**Drainage Report**

**New River Road Bridge  
Project No. 68738**

RE: New River Road Bridge at New River - 95% Plans  
MCDOT WO No. 68738

We have revised the enclosed drainage report in accordance with review comments from MCDOT and FCDMC for the above referenced 90% project submittal. The following addresses each comment specified in interoffice memos from the FCDMC (copy attached):

CHANNELIZATION PLAN  
FIGURE 3

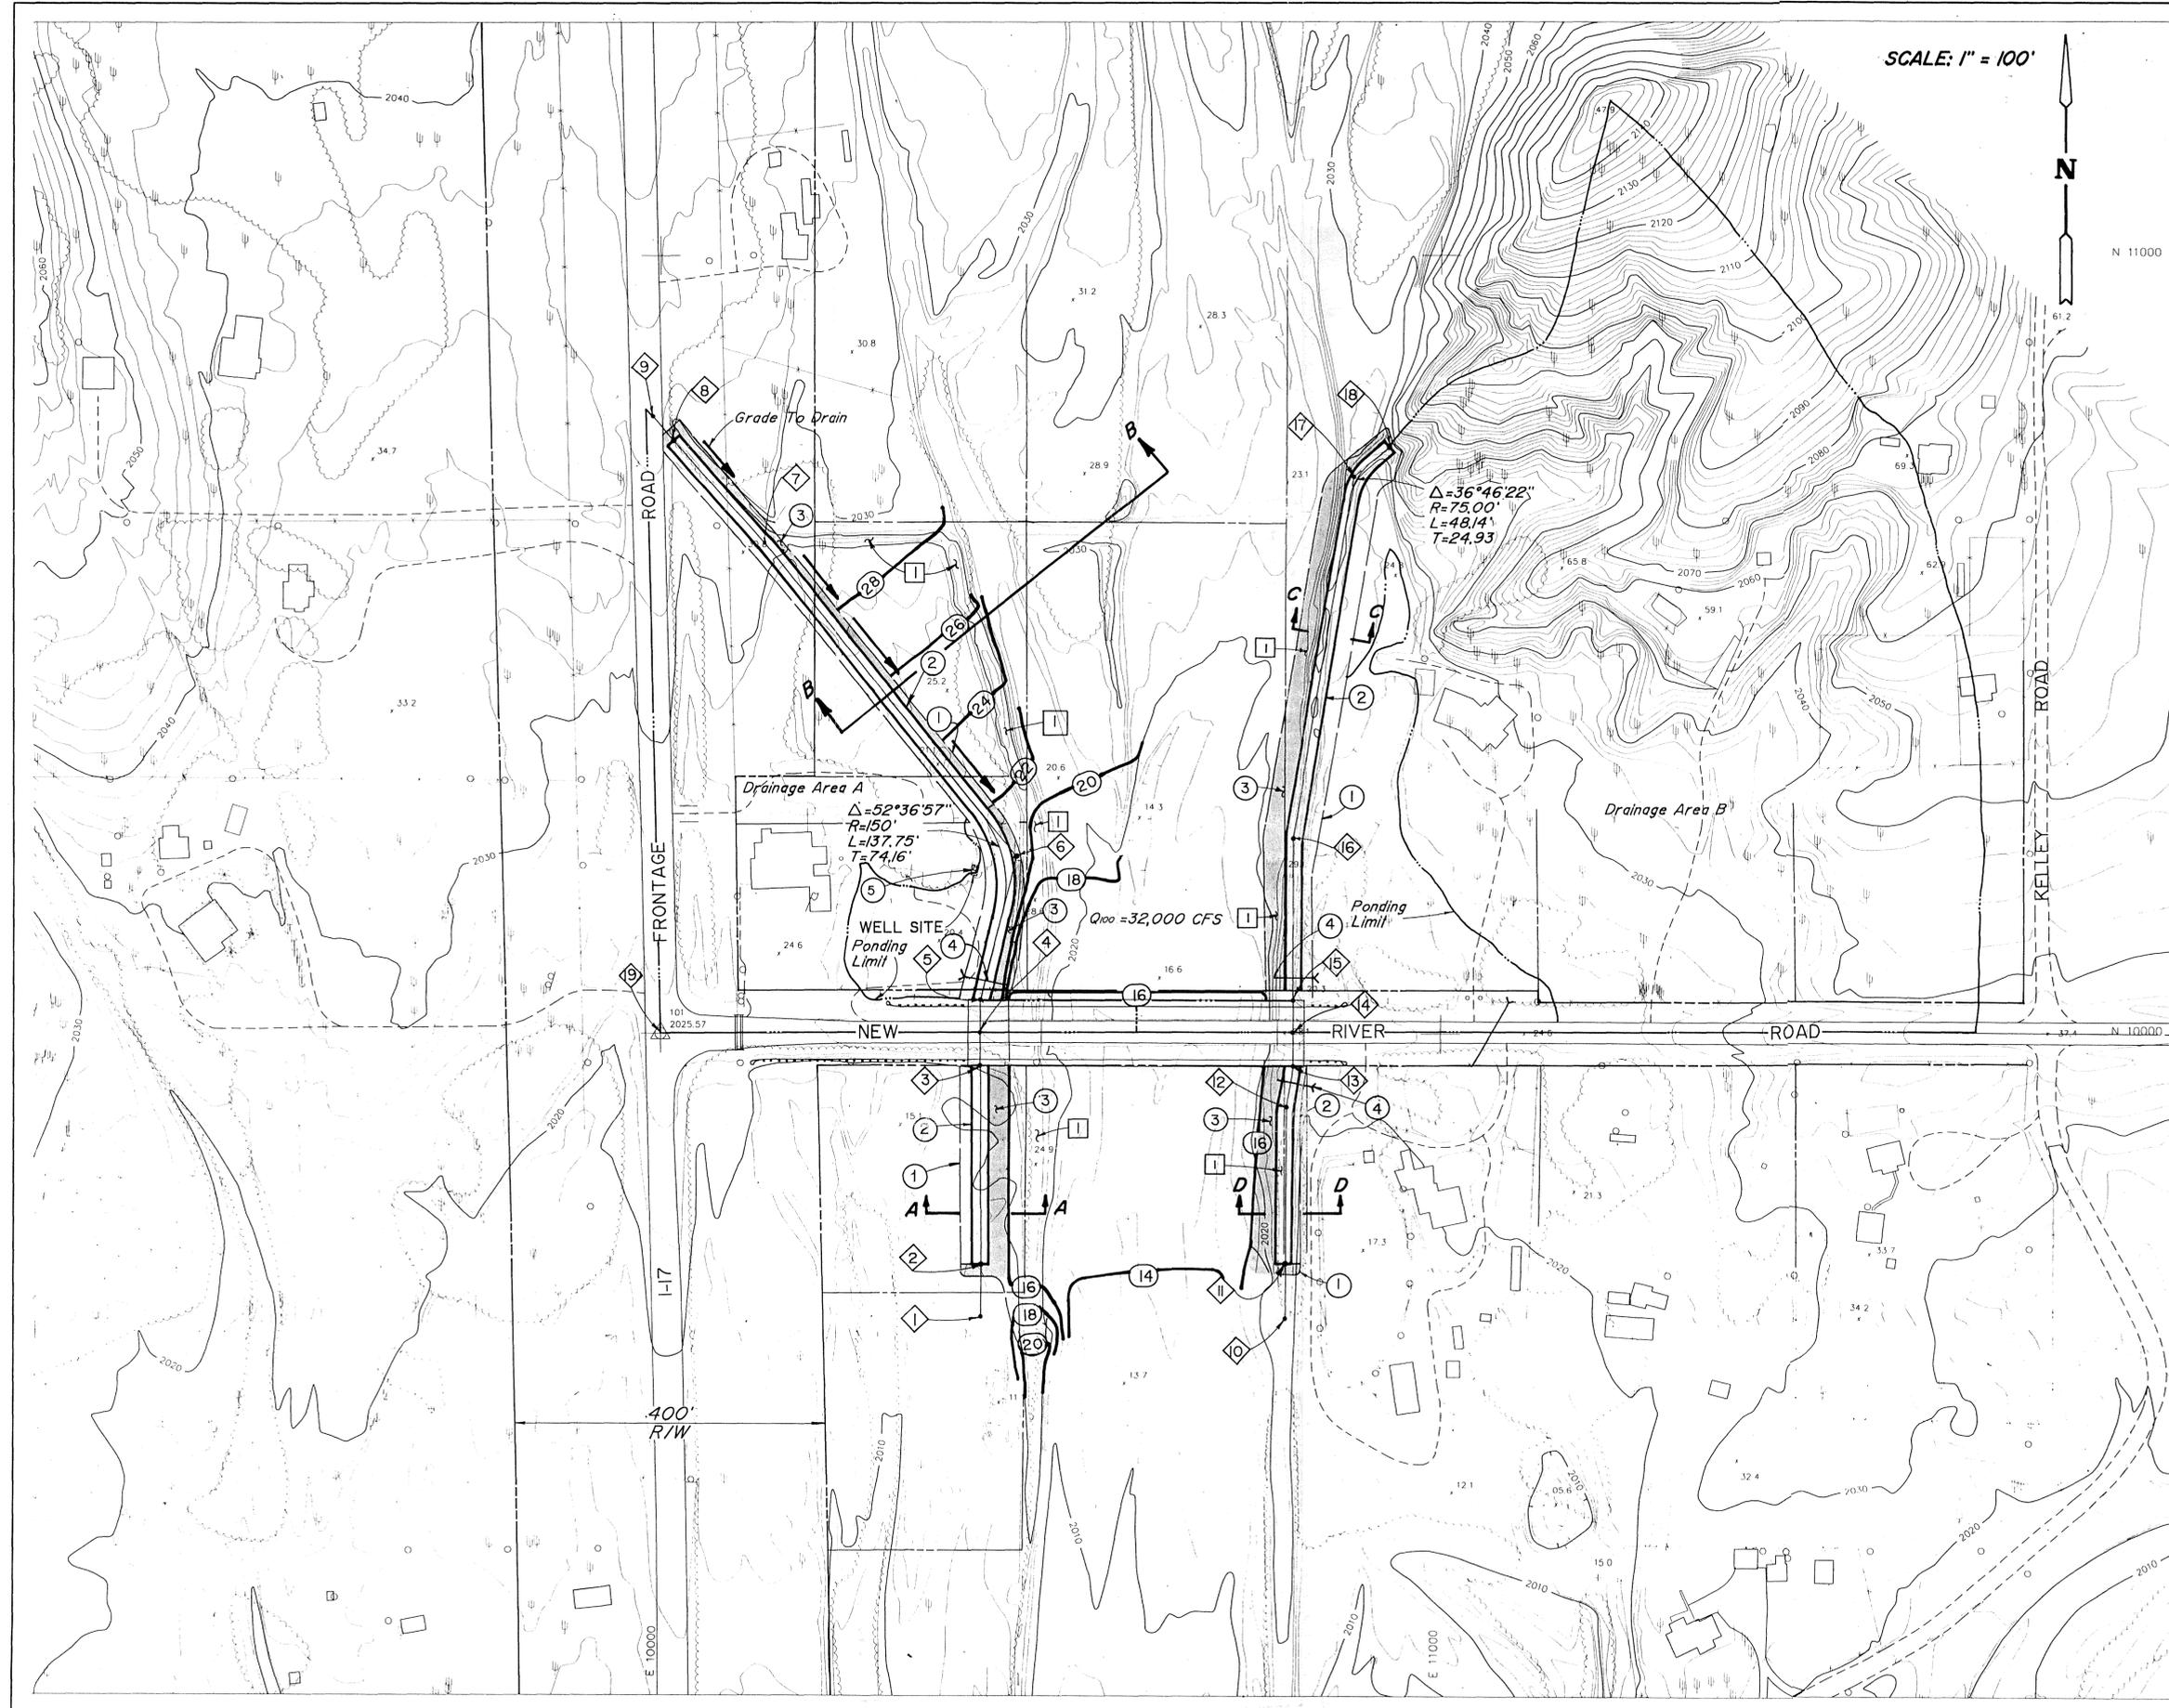
The pipe culvert should be analyzed assuming following two conditions: 1) 100-year flow in pipe with 10-year flow in channel and 2) 10-year flow in pipe with 100-year flow in channel. From above two conditions, the worse condition governs.

Pipe culverts have been designed based on 100-year flows in New River. Automatic drainage gates or more commonly called backflow prevention devices will be installed to prevent New River backwater effects to adjacent parcels. These pipe culverts have been designed to allow 100-year gravity drainage for adjacent parcels once floodwaters recede in New River. This analysis is the most conservative ("worse condition") case which will occur and is depicted on Figure 3 as ponding limits in the legend (See Appendix F).
